REPORT TO THE SUBDIVISION AND
DEVELOPMENT APPEAL BOARD

DATE: July 28, 2026	APPEAL NO.: SDAB2026-0105 FILE NO.: DP2026-00695
APPEAL BY: Kayla Cocco represented by Carol McClary	
FROM A DECISION OF THE DEVELOPMENT AUTHORITY where a New: Semi-detached Dwelling (east parcel), Backyard Suite (above garage), Accessory Residential Building (garage) was approved at <u>3530 2 Avenue SW.</u>	LAND USE DESIGNATION: R-CG Discretionary
COMMUNITY OF: Spruce Cliff	DATE OF DECISION: June 12, 2026
APPLICANT: MARCEL DESIGN STUDIO	OWNER/S: AMARPREET & HARJINDER SINGH

Detailed Review 1 (EAST) – Development Permit Response

SDAB2026-0105

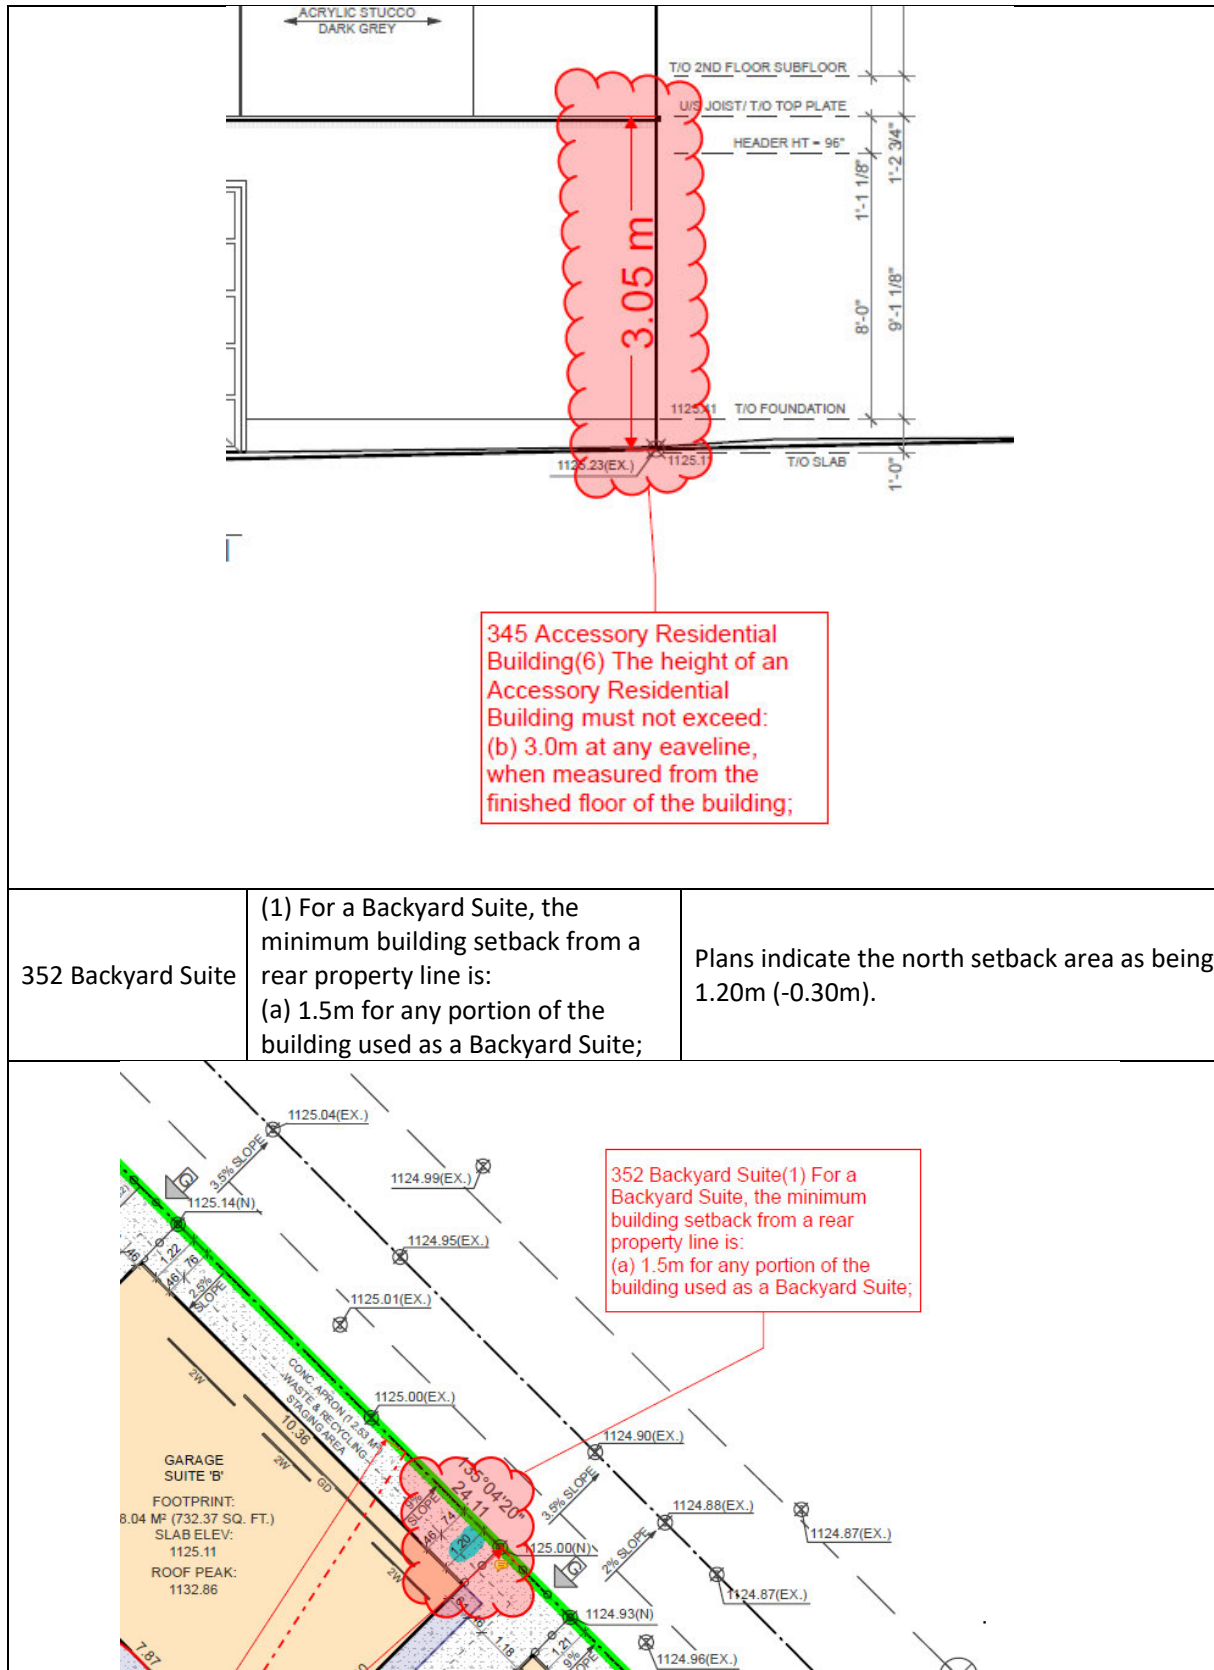
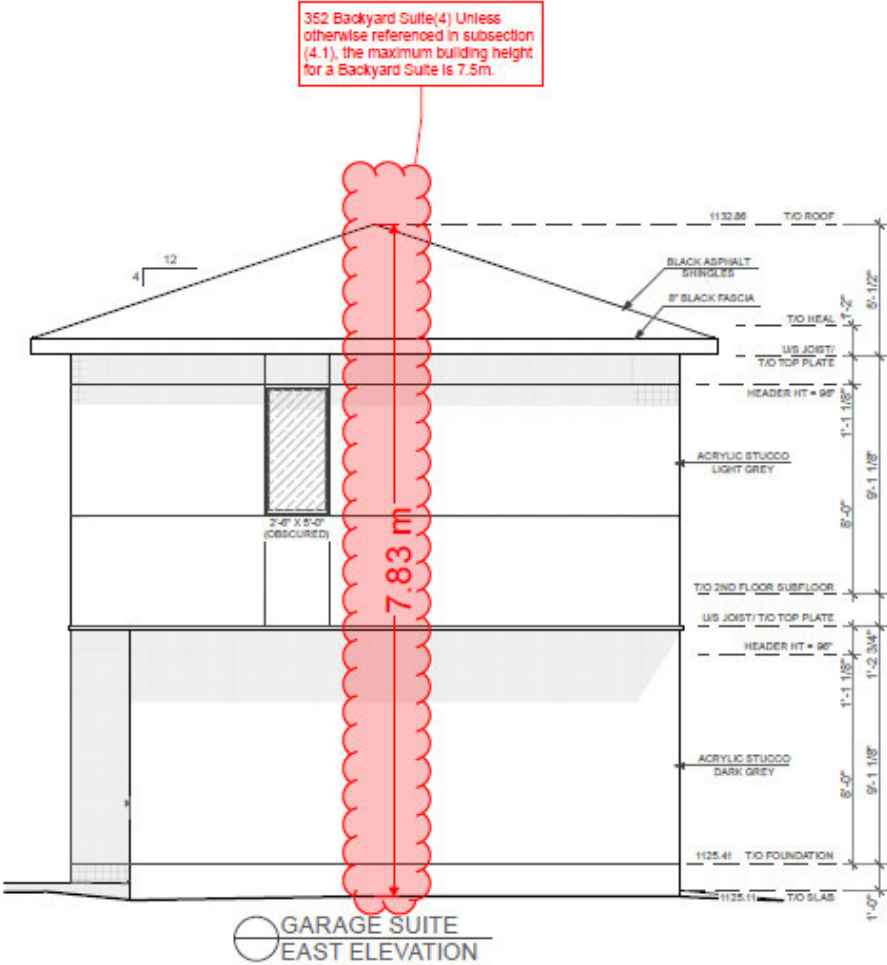
Bylaw Discrepancies		
Regulation	Standard	Provided
539 Building Setback from Side Property Line	(1) Subject to subsections (3) through (9), the minimum building setback from any side property line is 1.2m	Plans indicate the west setback area as being 1.19m (-0.01m). Revision required to comply with rule
351 Secondary Suite	(1) For a Secondary Suite the minimum building setback from a property line, must be equal to or greater than the minimum building setback from a property line for the main residential building.

352 Backyard Suite	(4) Unless otherwise referenced in subsection (4.1), the maximum building height for a Backyard Suite is 7.5m.	Plans indicate the height as being 7.87m (+0.37m).

352 Backyard Suite	(4.1) The maximum building height for a Backyard Suite is: (a) 5.0m measured from grade at a side property line shared with a parcel designated with a low density residential district; (c) increases at a 45 degree angle to a maximum of 7.5m at a proportional distance from the shared property line.	Plans indicate the west portion of the backyard suite as being within the height chamfer. Relaxation supportable

Amended

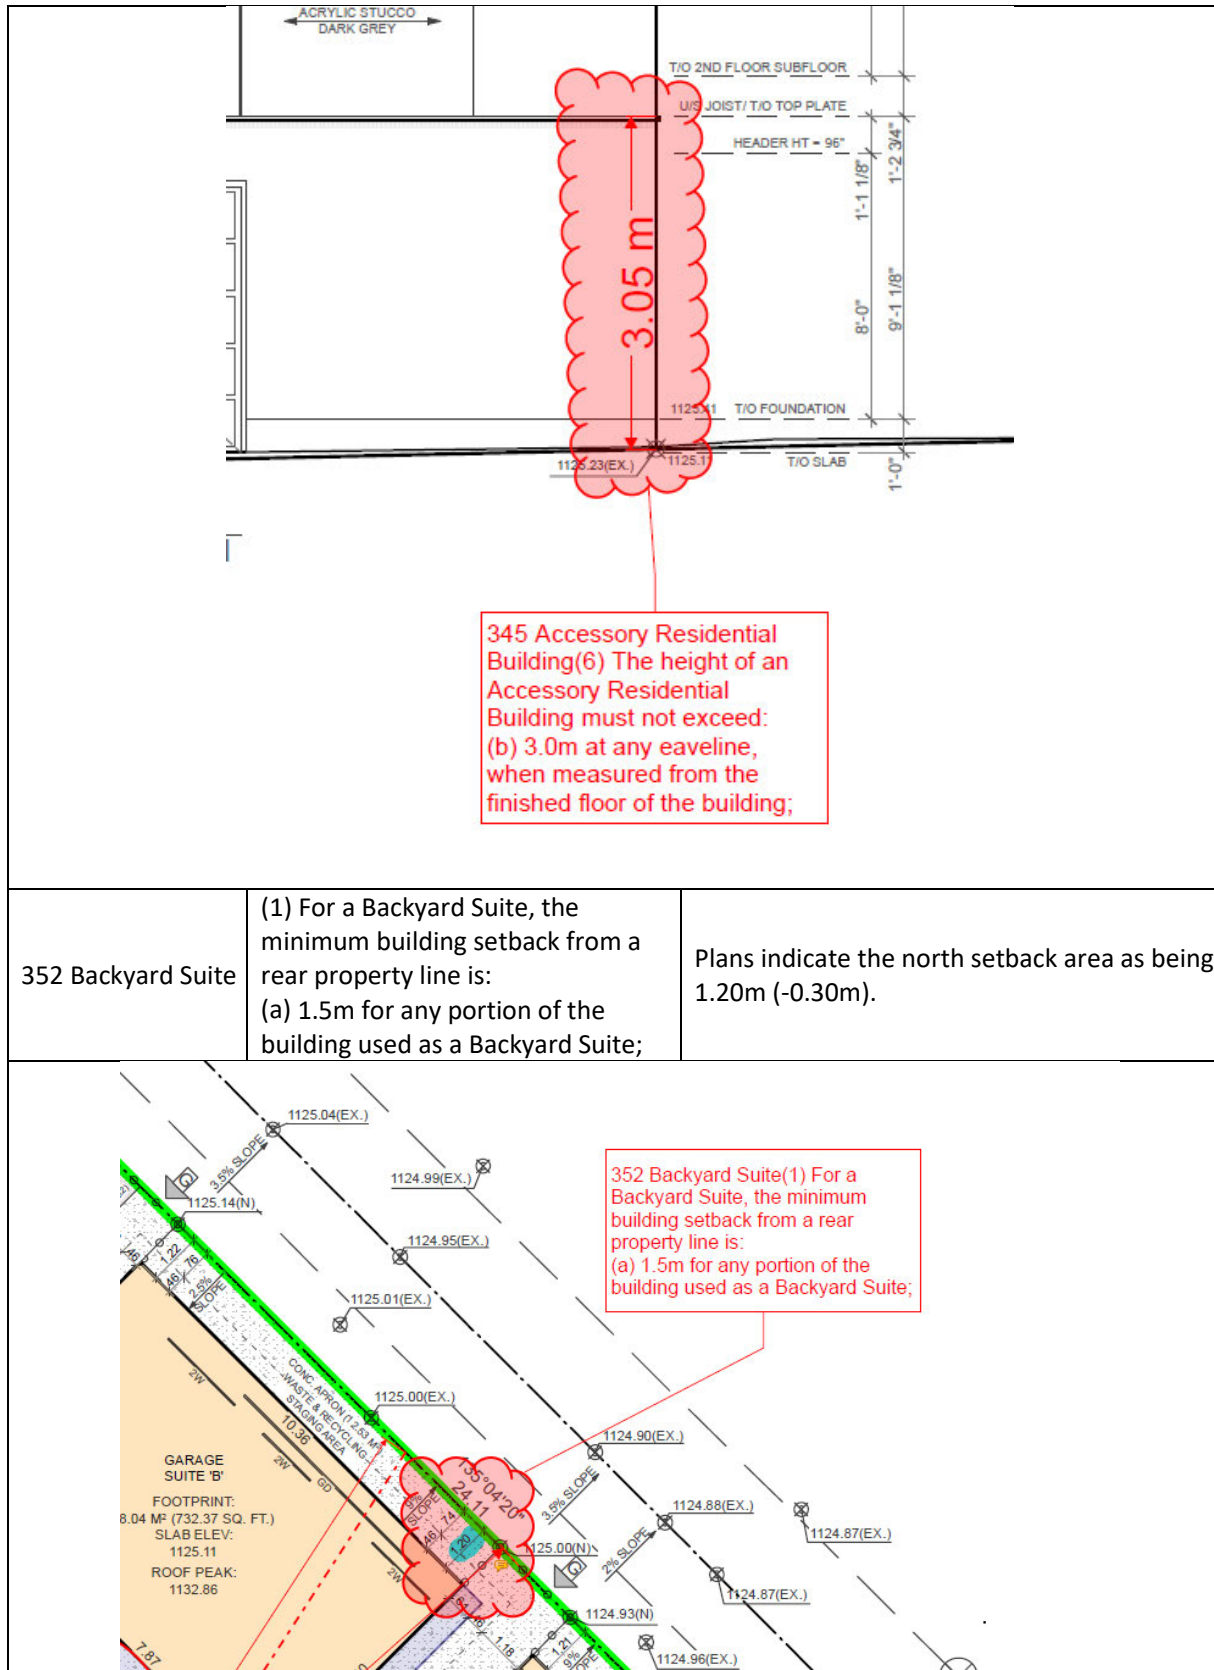
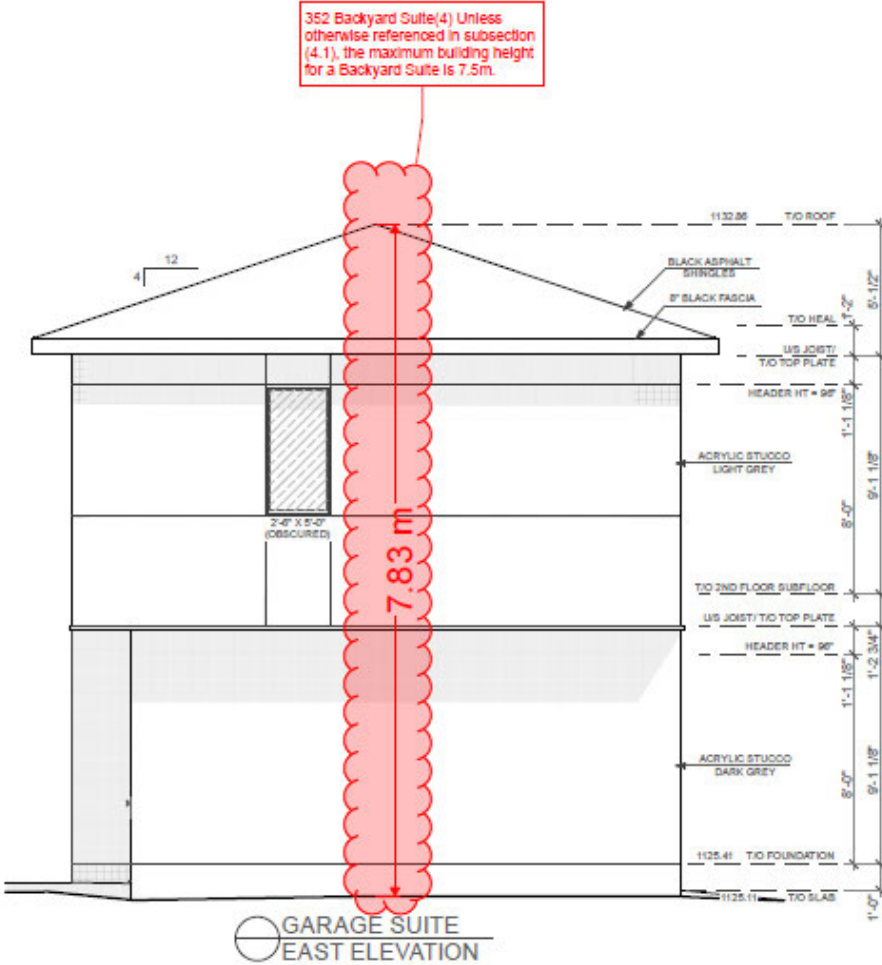
Bylaw Discrepancies		
Regulation	Standard	Provided
539 Building Setback from Side Property Line	(1) Subject to subsections (3) through (9), the minimum building setback from any side property line is 1.2m	Plans indicate the west setback area as being 1.19m (-0.01m). Revision required to comply with rule Amended
351 Secondary Suite	(1) For a Secondary Suite the minimum building setback from a property line, must be equal to or greater than the minimum building setback from a property line for the main residential building.

352 Backyard Suite	(4) Unless otherwise referenced in subsection (4.1), the maximum building height for a Backyard Suite is 7.5m.	Plans indicate the height as being 7.87m (+0.37m).
	352 Backyard Suite(4) Unless otherwise referenced in subsection (4.1), the maximum building height for a Backyard Suite is 7.5m.  GARAGE SUITE EAST ELEVATION	
352 Backyard Suite	(4.1) The maximum building height for a Backyard Suite is: (a) 5.0m measured from grade at a side property line shared with a parcel designated with a low density residential district; (c) increases at a 45 degree angle to a maximum of 7.5m at a proportional distance from the shared property line.	Plans indicate the west portion of the backyard suite as being within the height chamfer. Relaxation supportable Reduced by 0.30 meters

SITE PLAN
SCALE: 1:150
AREA CALCULATIONS

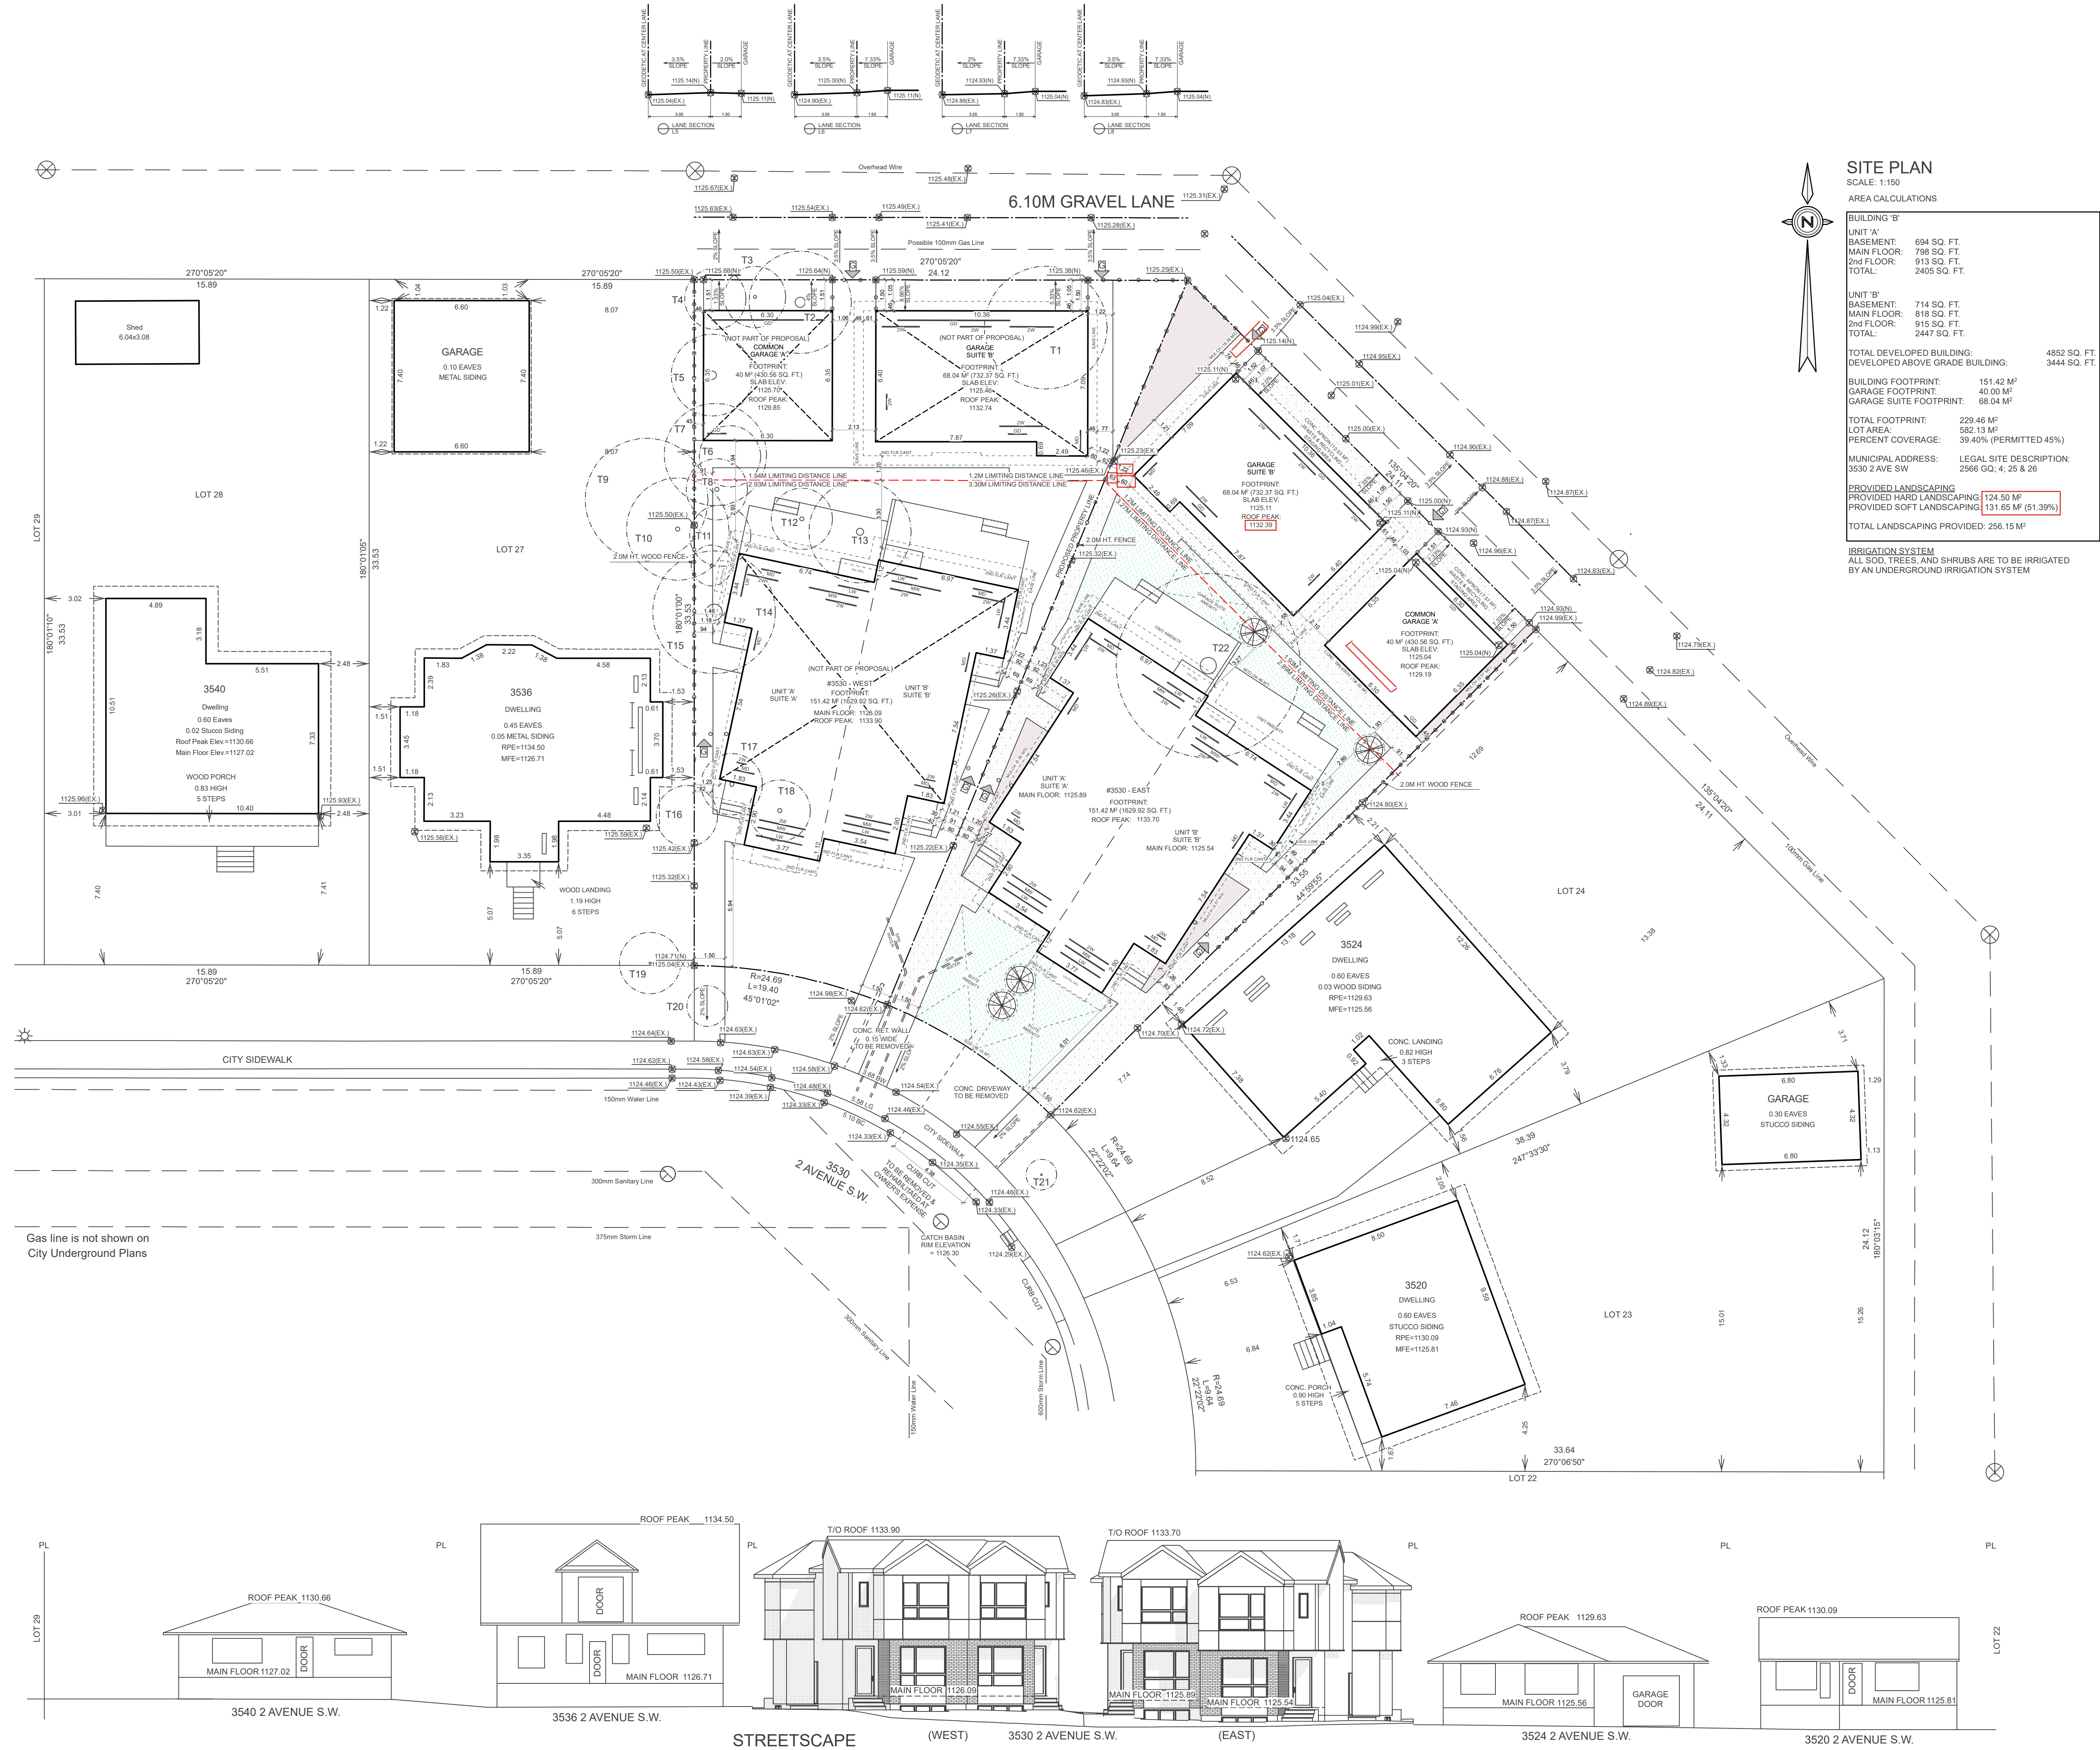
1. Please see the Reasons for Approval.
2. On April 8, 2026, Council approved the Repeal of Blanket Rezoning through Bylaw 9P2026. The bylaw takes force on August 4, 2026, at which point this parcel will have a land use designation of (R-C2). Where hearings are scheduled for after August 4, 2026, the Development Authority will provide the Board with an updated Bylaw Check reflecting applicable rule changes.
3. Visual representation of the relaxation for Section 352, the portion of the building extending into the chamfer is indicated in magenta.
